MCRP (N2) CP N-01 Vol-2 Sec-6 Drawings: Bid Query Batch-18; NO. 6. Ref: 104

"Architectural Works: Calumpit and Apalit Stations"

Consolidated Response: 26-Jun-2019

1.0 Floor Finish

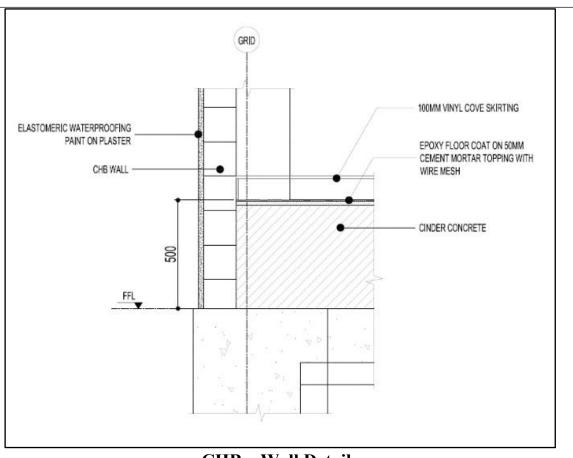
1.0 Floor Finish

- * T=100mm, Plain Mortar Wire Broom Finish
- * T=100mm, Plain Mortar Finish with Scouring
- * T=50mm, Pebble Washout Finish

- * T=100mm, Plain Mortar Wire Broom Finish Not included in the Schedule of Finish
- * T=100mm, Plain Mortar Finish with Scouring Not included in the Schedule of Finish
- * T=50mm, Pebble Washout Finish Not included in the Schedule of Finish

CHB – Wall Details

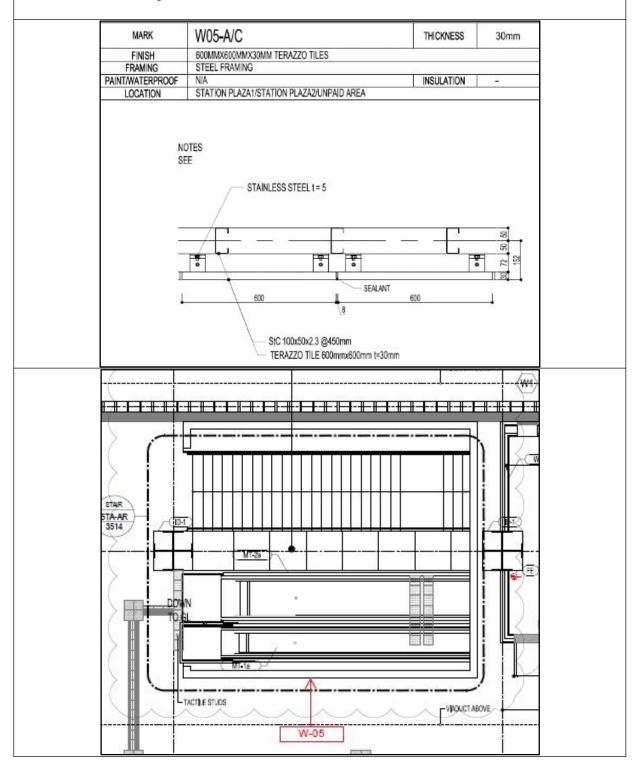
- * CHB Wall, Non-Load Bearing, (Including Reinforcing Steel); t=100
- * W05 Wall: 600 x 600 x 30mm, Terrazzo Tiles Dry Construction Method Cladding with W=8mm Joints including 100 x 50 x2.3mm Steel Cannel at 450mm O/C, T=5mm Stainless Steel Tile fixing Angles, tile joint Pointing and all necessary accessories.

* CHB Wall, Non-Load Bearing, (Including Reinforcing Steel); t=100. – Current drawings for this package include 150mm CHB exterior wall for small buildings (PSS, BP, ISER)-refer to PSS/SIG/BP-AR-3501"; Also Refer to Sketch Below which Provides further Details:
